Historic District Commission

City of Kalamazoo

Tuesday, February 20, 2024

E. APPLICATION REVIEWS

Night Time View

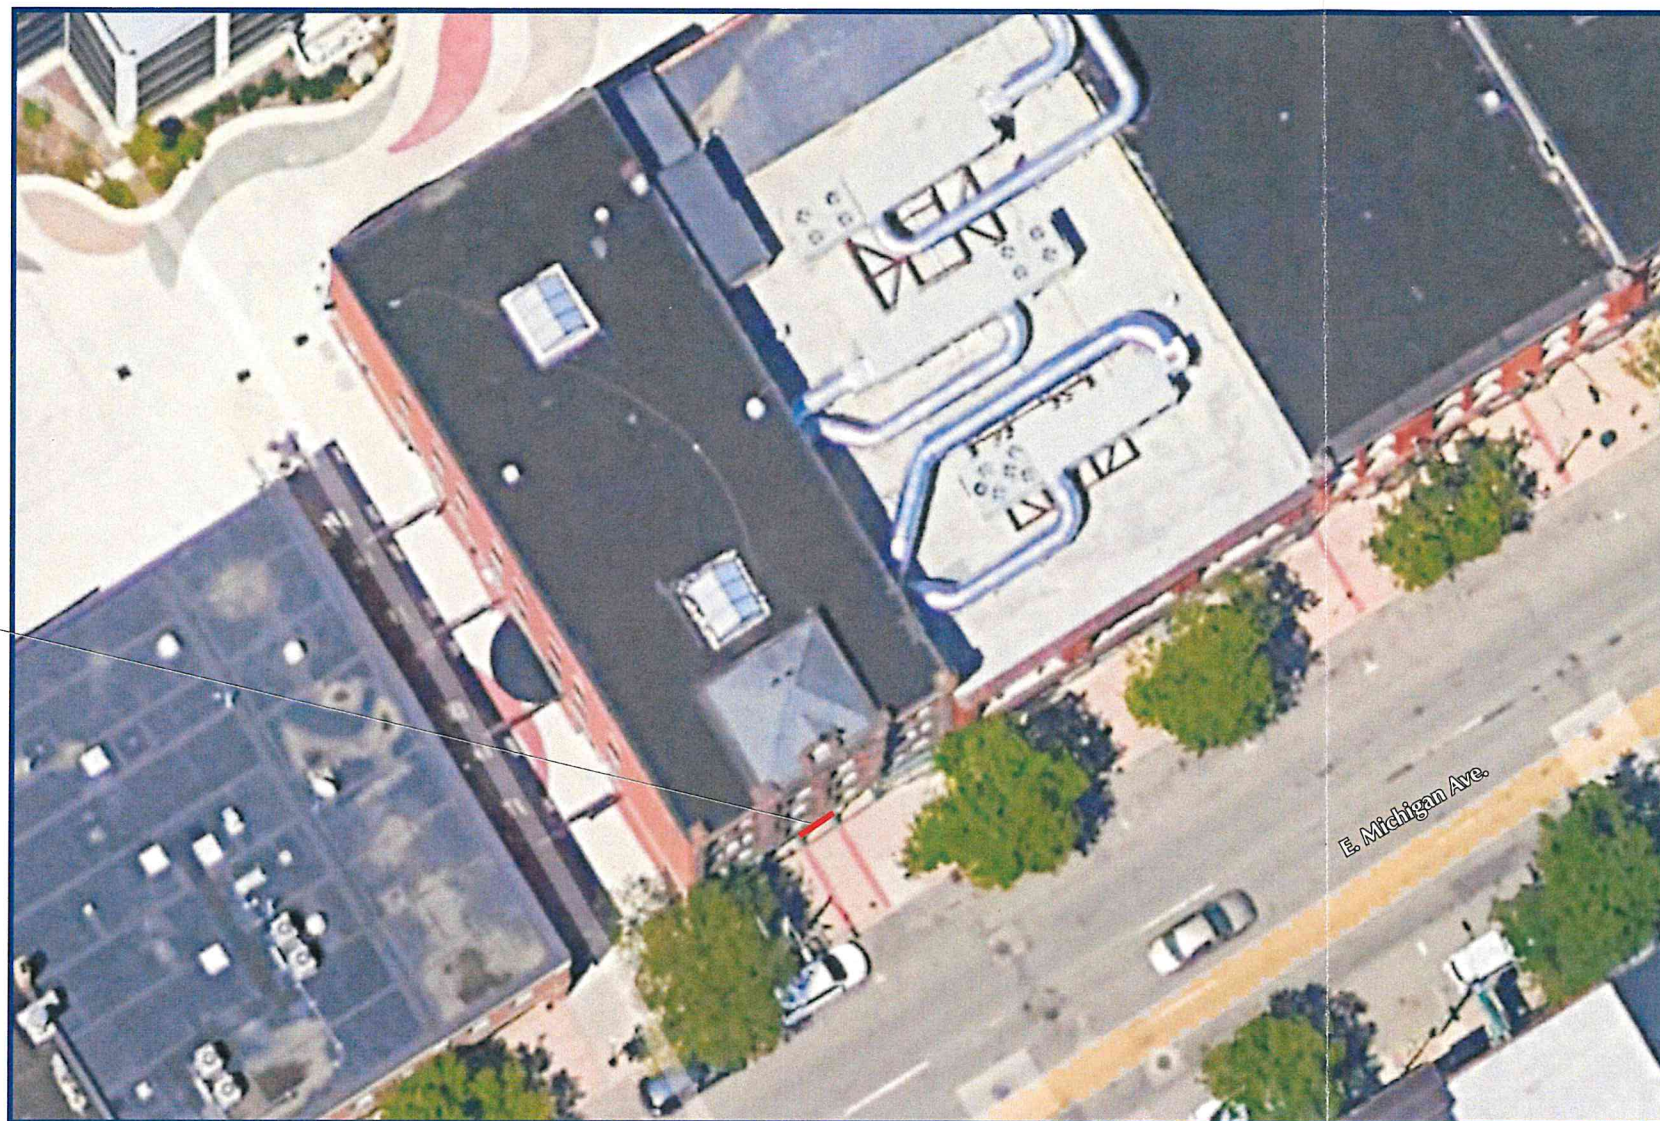
1. A property shall be used for its historic purpose or be placed in a new use that requires minimal change to the defining characteristics of the building and its site and environment. *Installing the sign on the property will not change the use of the building (commercial). Additionally, the installation of the sign will not constitute more than a minimal change to the building.*

1. The proposed work complies with the Secretary of the Interior standards 1, 2, 9 and 10. **Action: Motion to approve a Certificate of Appropriateness for the work as described in the application.**
2. More information is needed. **Action: Motion to postpone until the HDC meeting on 19 March 2024 and direct the applicant to provide the requested materials and information to the Historic Preservation Coordinator by noon on 12 March 2024.**
3. Denial of the application. **Action: Motion to deny the application based on Secretary of the Interior Standards 1, 2, 9 and 10.**

1 FIRST FLOOR PLAN
SCALE: 1/4" = 1'-0"

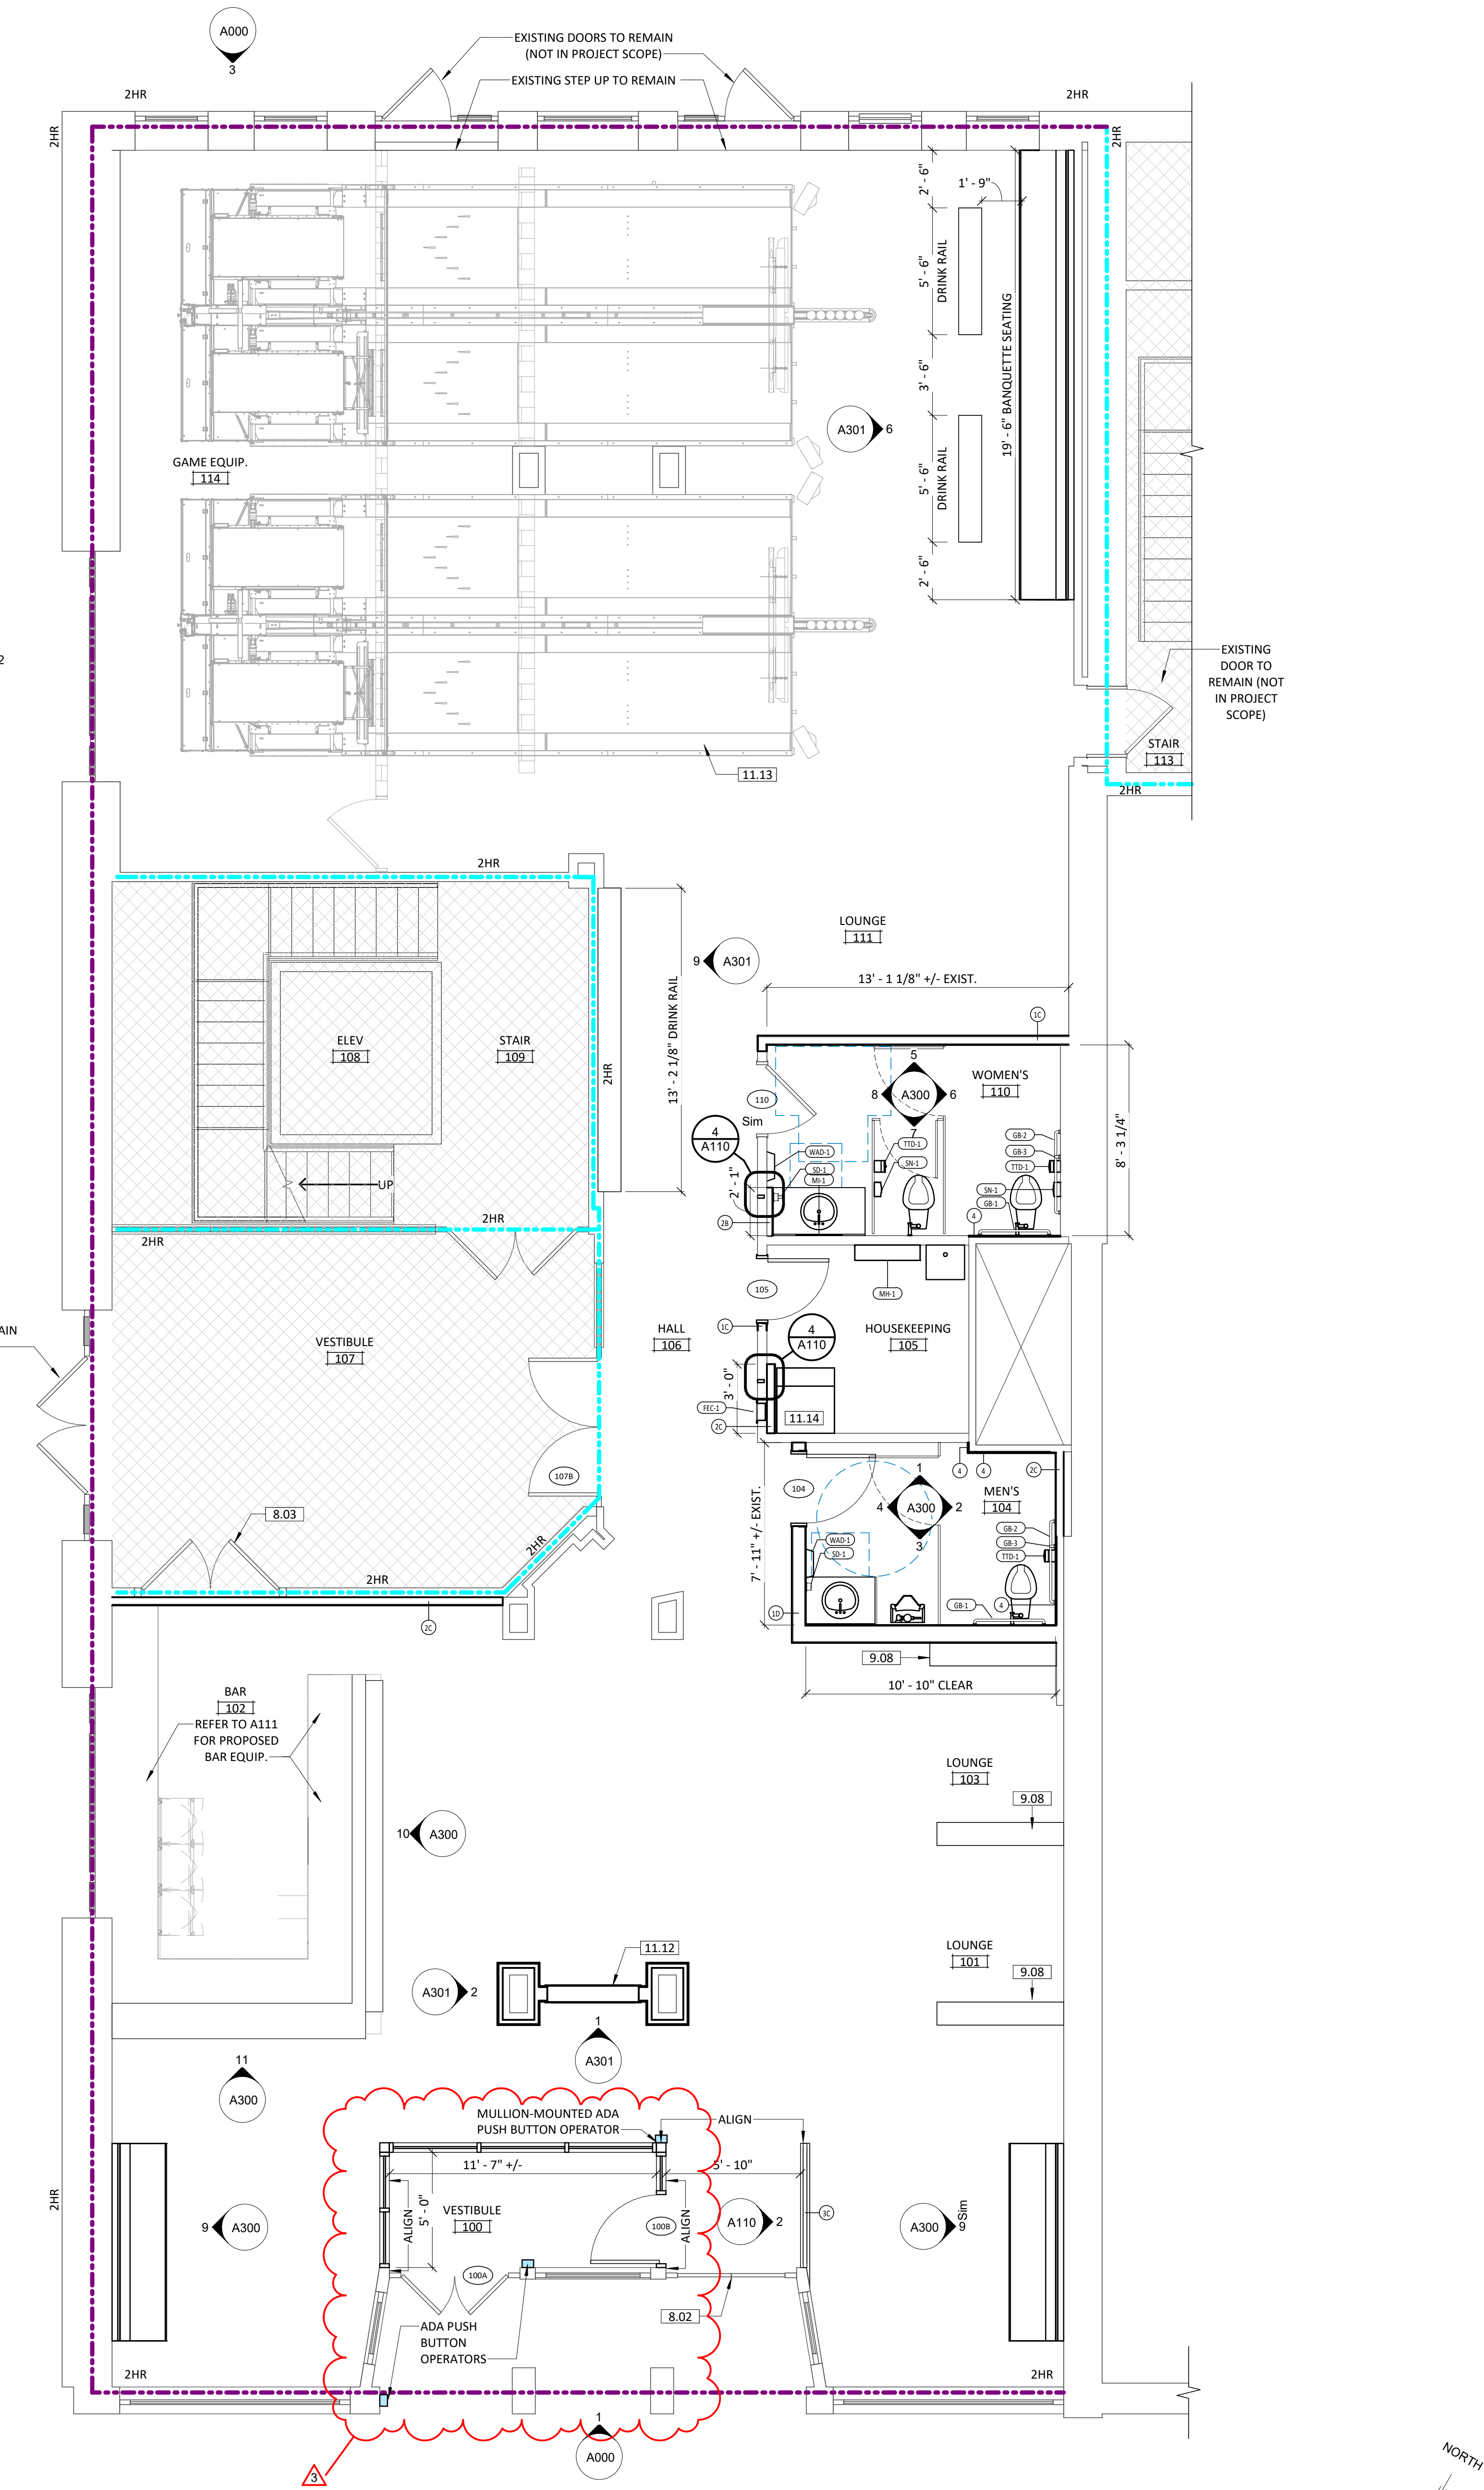
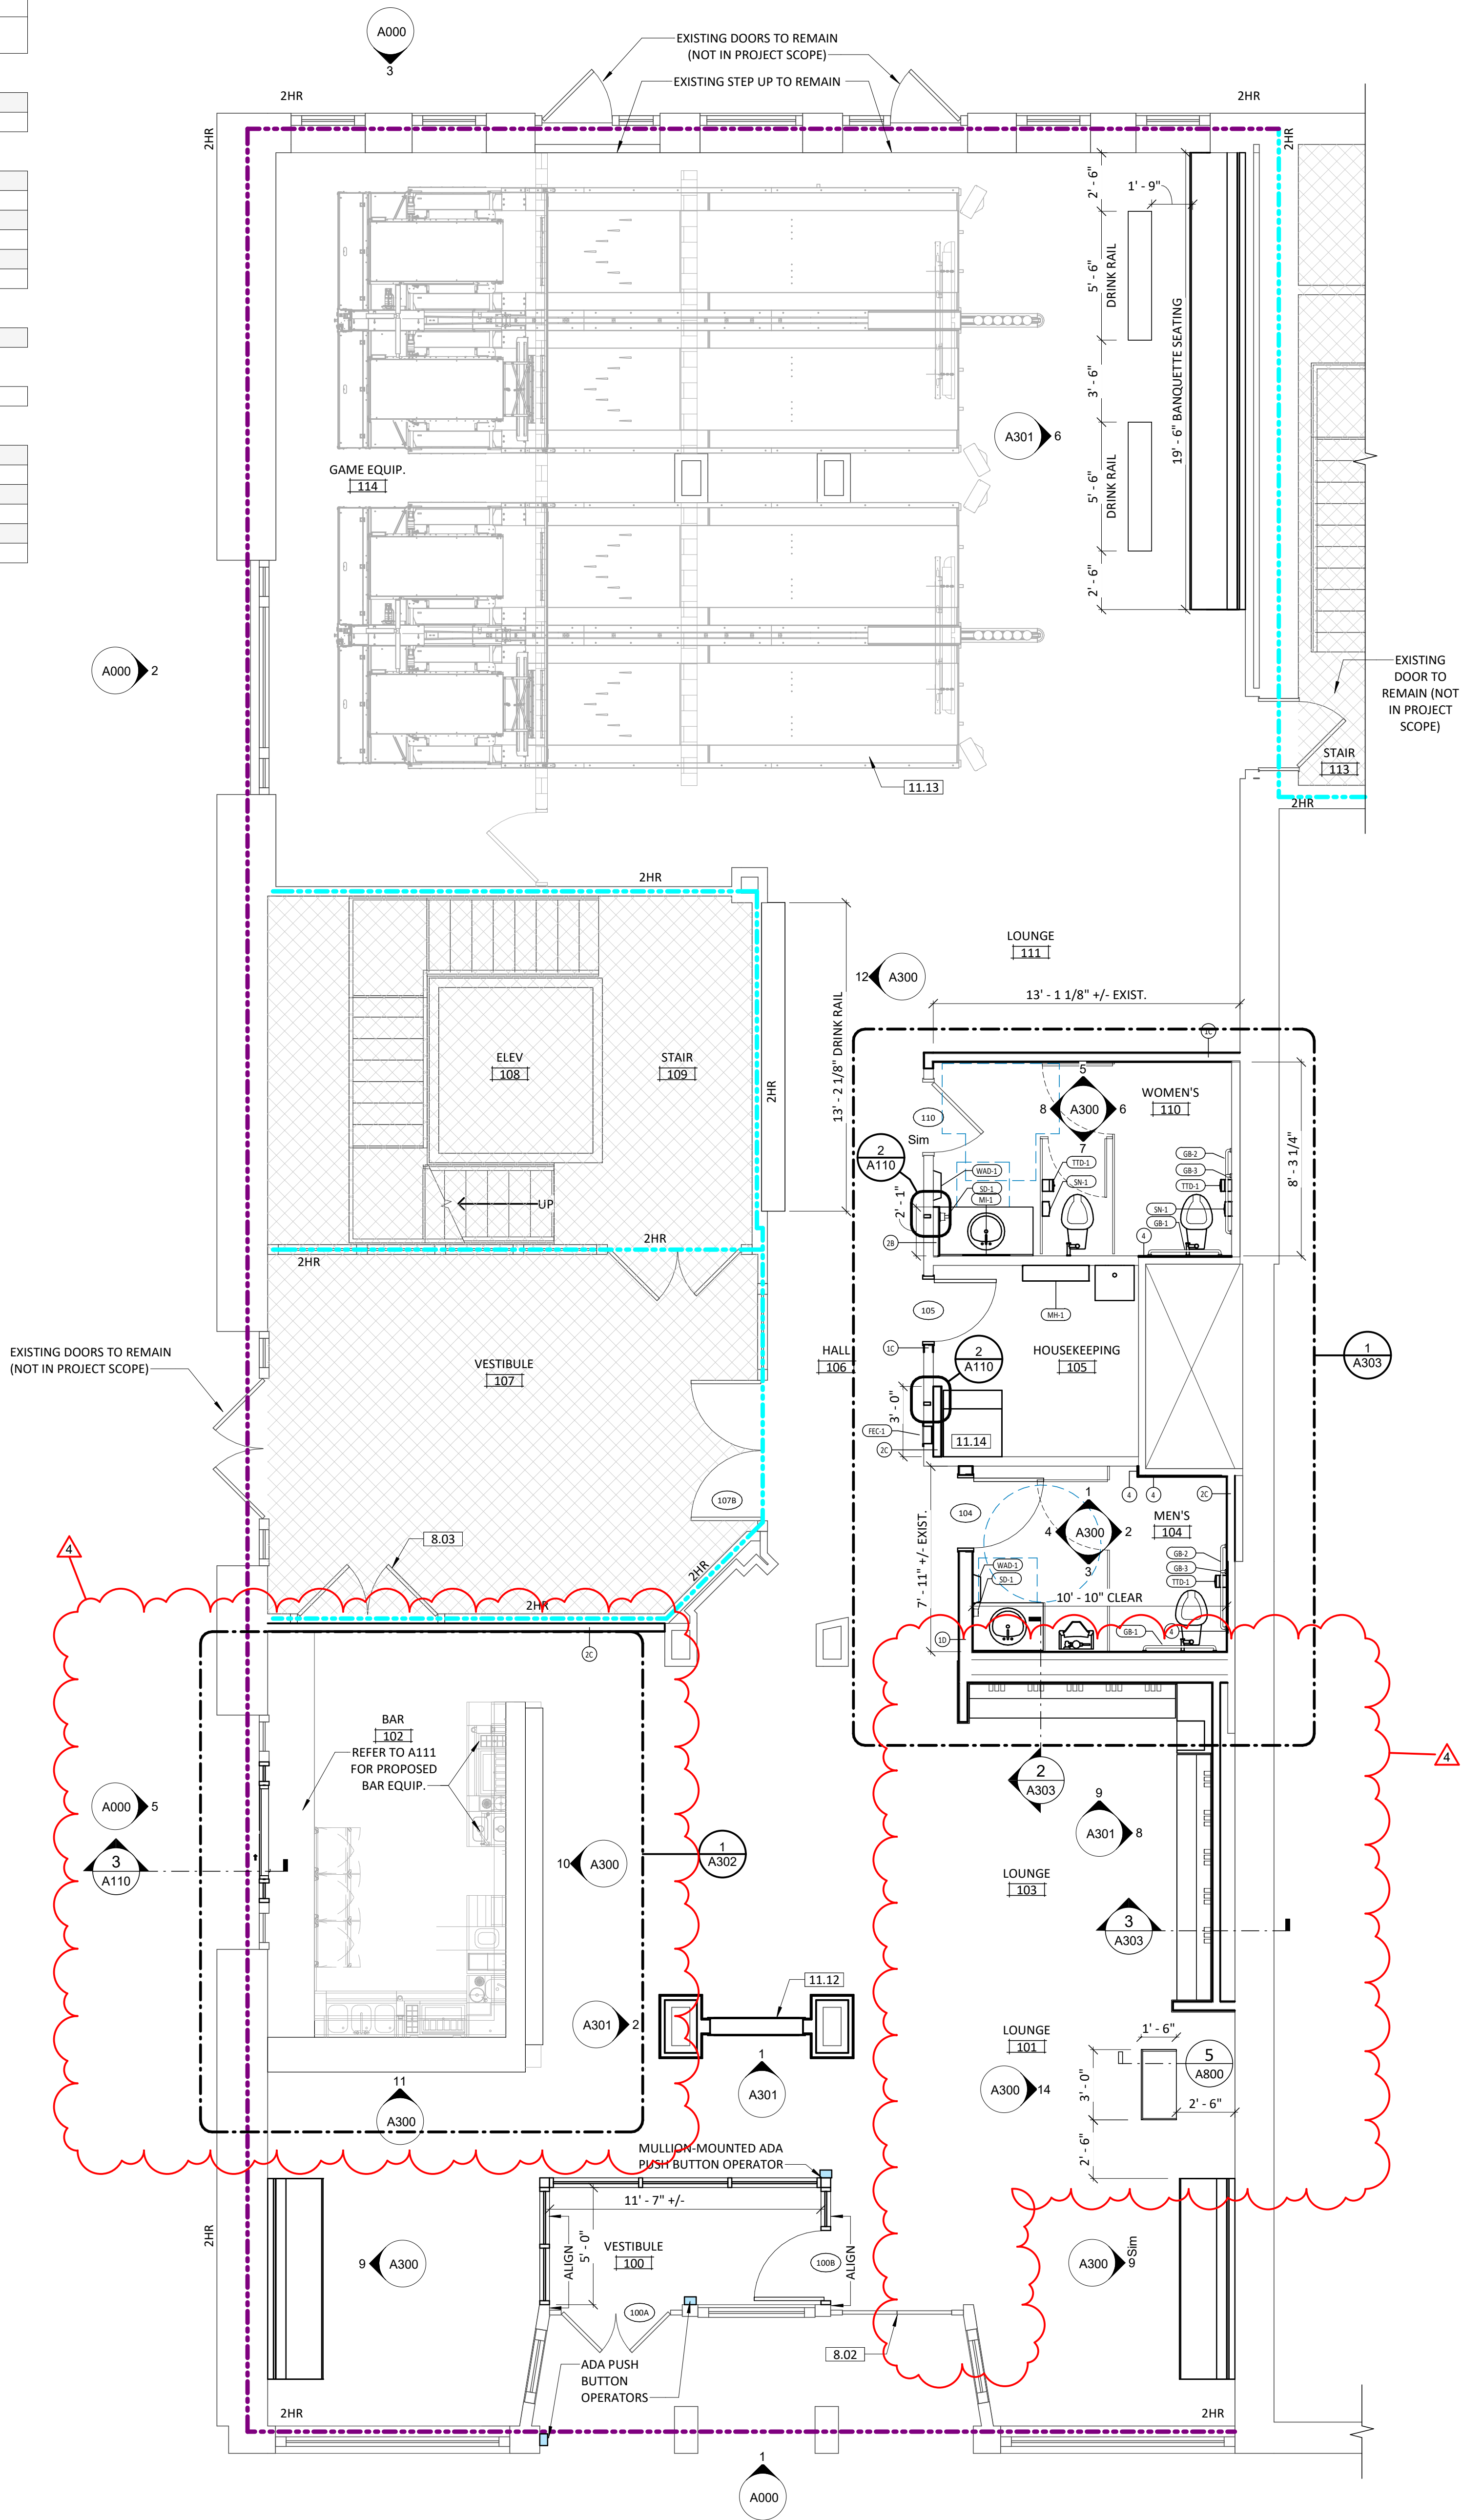
The property will continue to be used for its historic purpose as a commercial building. Neither the ADA button or the service window will constitute a change to the defining characteristics of the building.

2. More information is needed. **Action: Motion to postpone until the HDC meeting on 19 March 2024 and direct the applicant to provide the requested materials and information to the Historic Preservation Coordinator by noon on 12 March 2024.**
